May 26, 2021

Project No. 1894269

**RESPONSE TO TCEQ INFORMATION REQUEST
PERMIT AMENDMENT APPLICATION
USA WASTE OF TEXAS LANDFILLS, INC.
HAWTHORN PARK RECYCLING & DISPOSAL FACILITY, TCEQ PERMIT MSW-2185A
HOUSTON, HARRIS COUNTY, TEXAS
TRACKING NO. 25937311, 26099680; RN102664232 / CN602560930**

4.1.1 Perimeter Monitoring Network

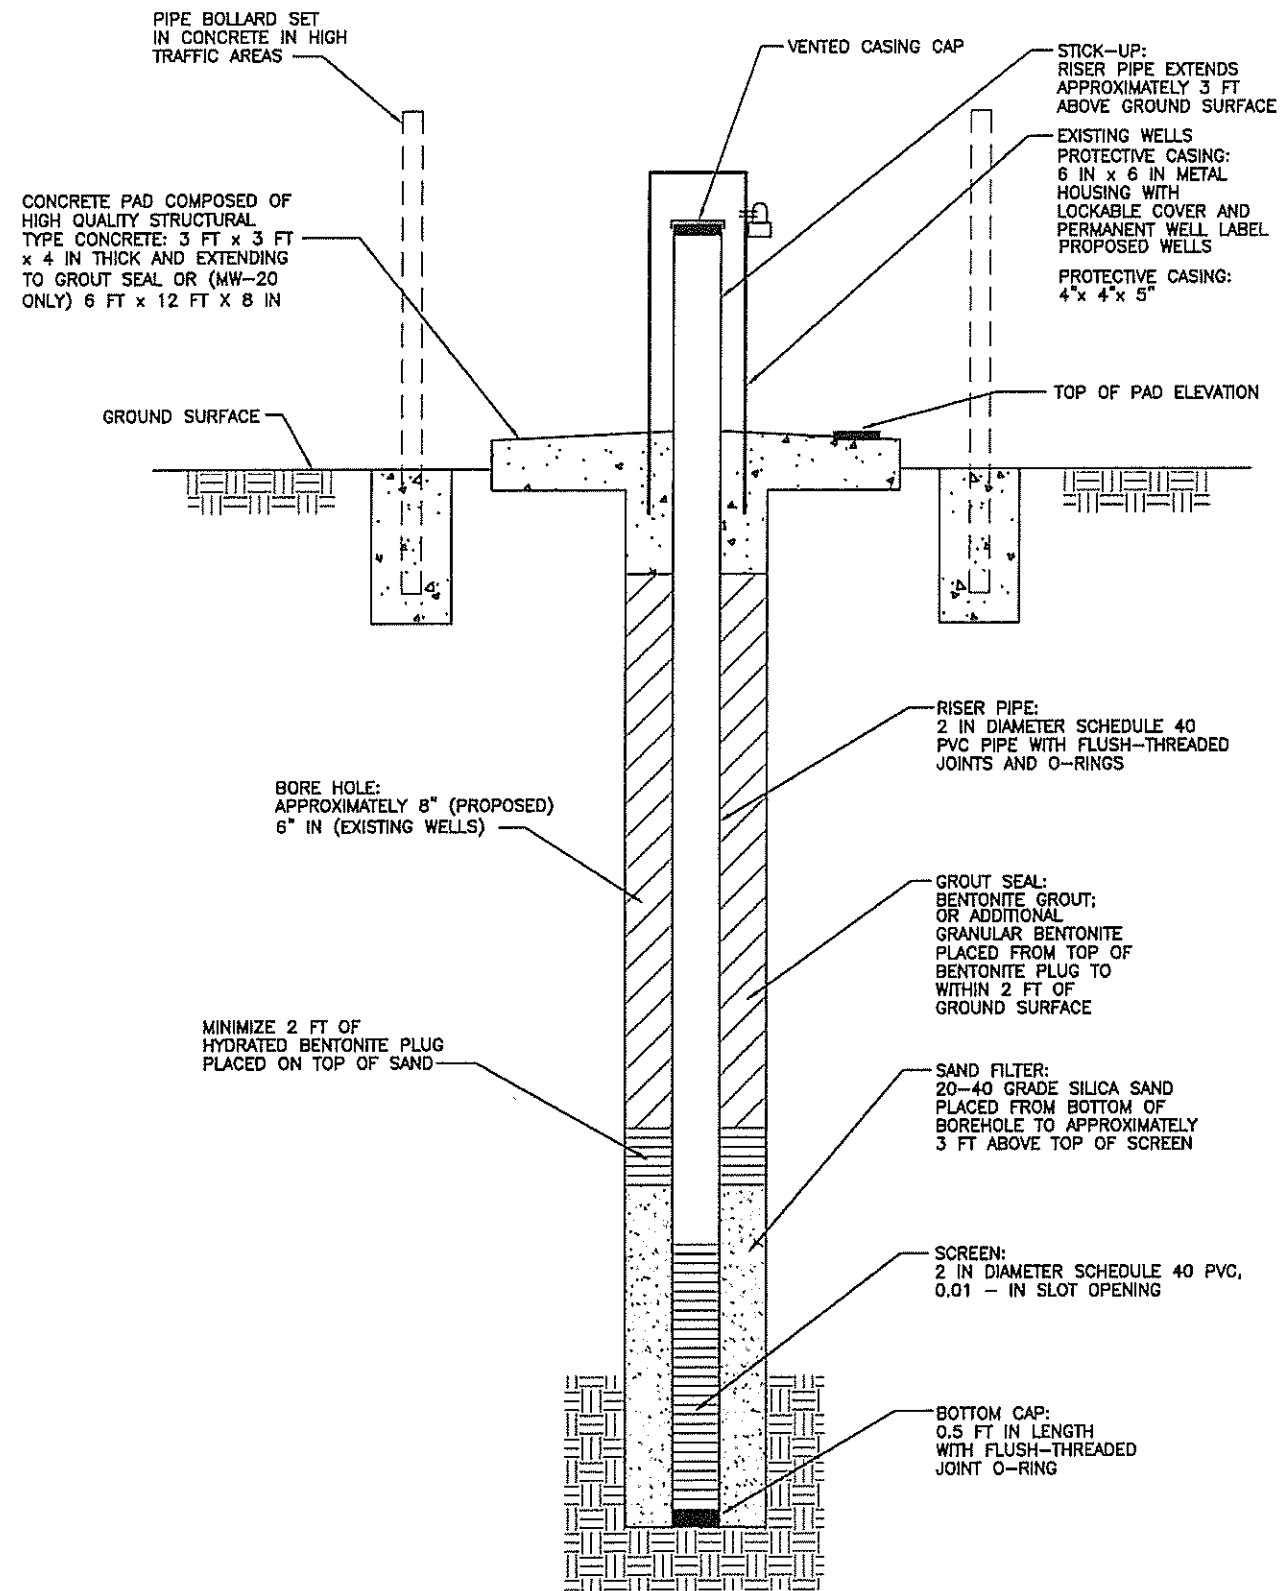
Comment T5	672	Part III	330.371(h)(2)	Attachment 6	Incomplete	Provide location of GP-23 in Figure III-6-3.	Part III, Attachment 6, Section 4.1.1 has been revised to indicate that GP-22, not GP-23, is the gas probe for compliance monitoring. The reference to GP-22 on Figure III-6-3 was the correct reference.
Other		Part III		Attachment 5			Figure III-5A-2 has been revised to remove monitoring well MW-9. This monitoring well is an interior well which will need to be removed as part of the expansion. No other text or figures need to be revised as a result of this revision.

The Hawthorn Park RDF's methane monitoring network will be expanded in phases to include the expansion area. Existing methane probes in the expansion area and off the permit boundary in the vicinity of the off-site detention pond will be abandoned upon approval of MSW 2185A. Proposed gas probes GP-28, GP-29, and GP-30 will be installed upon approval of MSW-2185A. Temporary probes may be installed at the site for evaluation purposes. Gas probes for compliance monitoring are GP-1A, GP-2, GP-3, GP-4, GP-8, GP-10, GP-11, GP-12, GP-13, GP-15, GP-18, GP-~~2322~~, GP-25, GP-26, GP-28, GP-29, and GP-30. The proposed perimeter monitoring network is shown on Figure III-6-3.
